INVITATION FOR BIDS NO. 15-089

REPAIR AND RESURFACING OF HARMONY TERRACE, ETC.

Addendum No. 2

**SUBJECT: BID #15-089 - Repair & Resurfacing of: Harmony Terrace, Etc.
Addendum #2**

EXTRUDED CURB
(FOR REPLACEMENT)

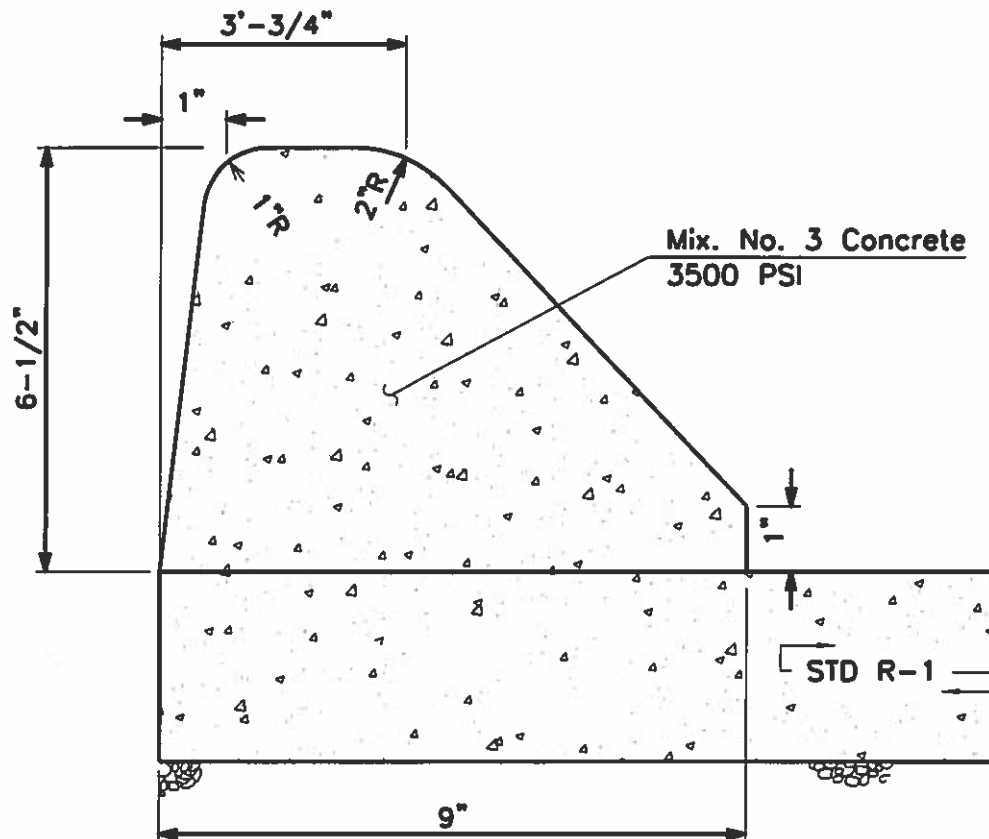
4. In Section 5 – Details - remove page 5-8 - Extruded Curb and replace with revised page 5-8 - Extruded Curb (For Replacement) with a revision date of 01/15/2015.

4. **A Contractor asked if 4"x4" key was necessary when placing new concrete curb.**

Expansion joint material, to be placed every 50' and at P.C.'s and P.T.'s of all curves.

The County replied that the key is not needed. Note that extruded curb detail will be revised in an addendum.
